Report To: MAYOR AND COUNCIL
Date: JULY 16, 2009
From: RUSS FUOCO, DIRECTOR OF PLANNING
Subject: REZONING AND SUBDIVISION APPLICATIONS
Files: SUB00596; REZ00439 - 5087 & 5093 LOCHSIDE DRIVE

To: Subdivision Office
From: Jagtar Bains – Development Coordinator
Date: July 28, 2009
Subject: Servicing Requirements for Development

PROJECT: TO REZONE FROM RS-18 TO RS-12 AND RS-8 TO CREATE ONE ADDITIONAL LOT FOR SINGLE FAMILY DWELLING USE

Figure #2: Tentative Subdivision

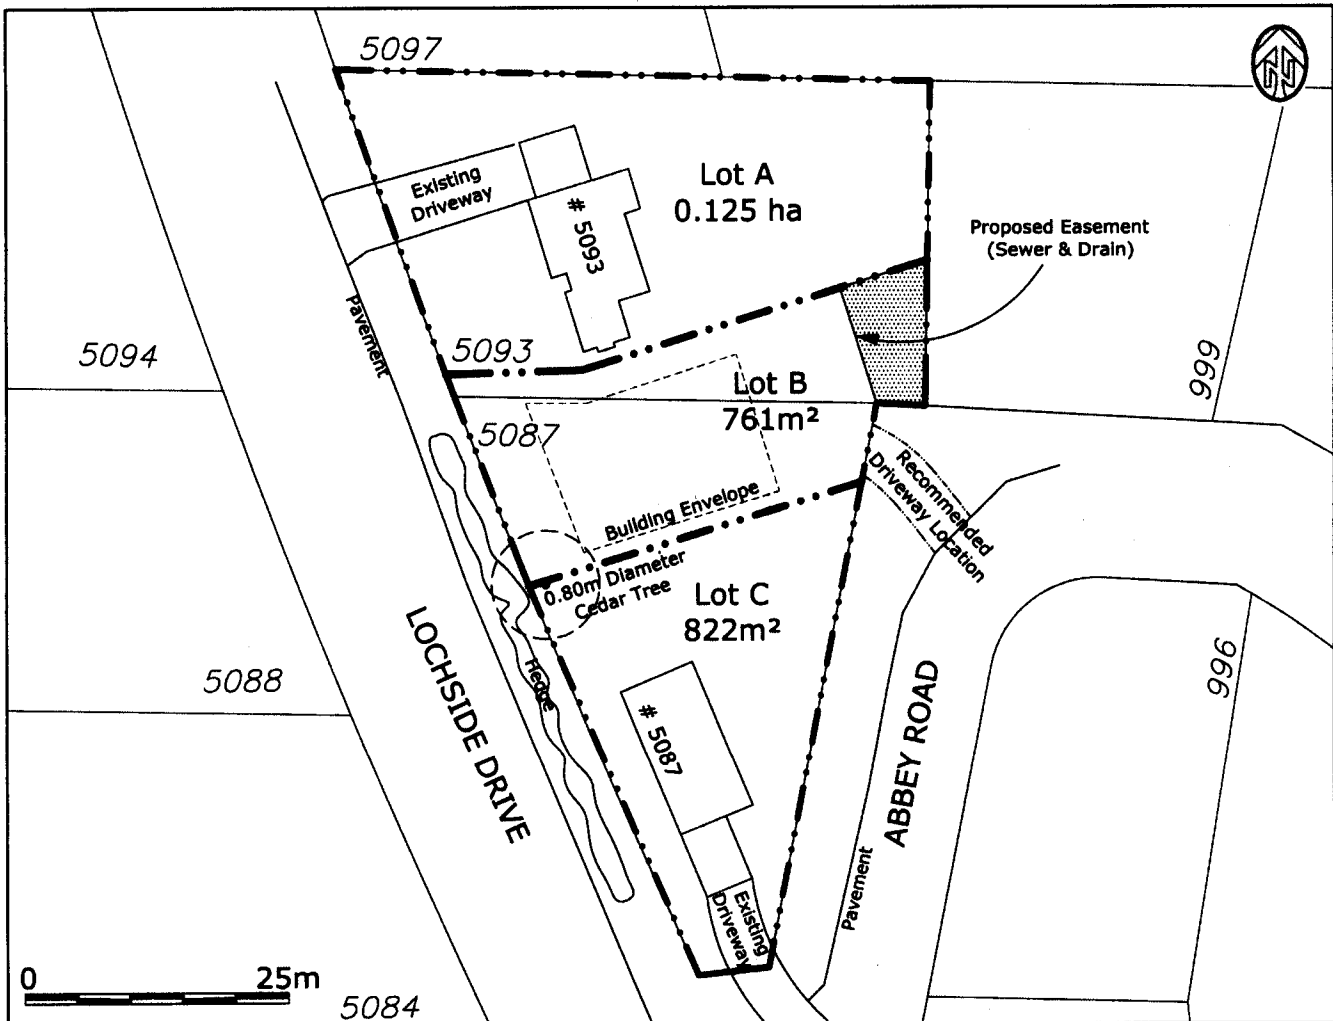
A 0.8 m diameter Cedar tree located near the southwesterly corner of proposed Lot B contributes to the treed character of Lochside Drive and should be protected during development. Restricting the access location for the proposed new lot to Abbey Road would avoid driveway construction impacts to the tree.

The vegetation along the Lochside Drive is a significant feature of the streetscape and recognized in the Lochside Drive Action Plan. The applicant has provided a proposed site plan showing potential driveway locations on both Lochside Drive and Abbey Road. If the proposed Lot B driveway were to be restricted to Abbey Road, no additional access points to Lochside Drive would be necessary and an existing hedge within the boulevard could be retained. Where possible, servicing corridors would follow the existing driveway alignments. Additionally, one Boulevard Street Tree would be required as specified in Schedule "I" of the Subdivision Bylaw. Restricting any new access driveway construction to Abbey Road should maintain the treed character of the Lochside Drive streetscape. A suitable covenant could be considered in the subdivision process.

DRAIN - 1. THE EXISTING SUBSTANDARD DRAIN ON ABBEY ROAD, BETWEEN THE EXISTING MANHOLE FRONTING PROPOSED LOT C AND THE CULVERT CROSSING FRONTING 995 ABBEY ROAD, MUST BE UPGRADED TO MUNICIPAL STANDARDS. ALSO, THE EXISTING MANHOLE ON ABBEY ROAD, FRONTING PROPOSED LOT C MUST BE REPLACED WITH A STANDARD MUNICIPAL MANHOLE.

GENERAL - 2. PRIVATE EASEMENTS WILL BE REQUIRED FOR SEWER AND STORM DRAIN ACROSS PROPOSED LOT B IN FAVOR OF PROPOSED LOTS A AND C AFTER THE EXACT LOCATIONS OF THE EXISTING CONNECTIONS HAVE BEEN DETERMINED.

GENERAL - 3. THE EXISTING RETAINING WALL FOR LOT A IS ENCROACHING ON PROPOSED LOT B. THIS WALL MUST BE RELOCATED OR COVERED BY AN EASEMENT.

ROAD - 2. DRIVEWAY TO PROPOSED LOT B IS TO BE CONSTRUCTED FROM ABBEY ROAD ONLY. THE EXISTING POLE, FRONTING THIS LOT ON ABBEY ROAD, WILL REQUIRE RELOCATION TO ACCOMMODATE THIS DRIVEWAY.

ROAD - 4. THE EXISTING PAVEMENT ON ABBEY ROAD, FRONTING THIS SUBDIVISION, MUST BE WIDENED TO 6.0 M COMPLETE WITH ASPHALT WATER CONTROL.

SEWER - 1. SUBSEQUENT SEWER CONNECTION WILL BE REQUIRED FOR PROPOSED LOT B FROM THE EXISTING MAIN ON ABBEY ROAD.

SEWER - 2. THE EXISTING SEWER CLEANOUT ON ABBEY ROAD, FRONTING PROPOSED LOT B, MUST BE REPLACED WITH A STANDARD MUNICIPAL MANHOLE.

WATER - 1. PROVISIONAL WATER CONNECTION WILL BE REQUIRED FOR PROPOSED LOT B.

WATER - 2. THE EXISTING 13MM WATER SERVICES TO PROPOSED LOTS A AND C, MUST BE UPGRADED TO 19MM.

- Provision of a suitable covenant to prohibit the construction or use of any driveway access on proposed Lot B leading to Lochside Drive.
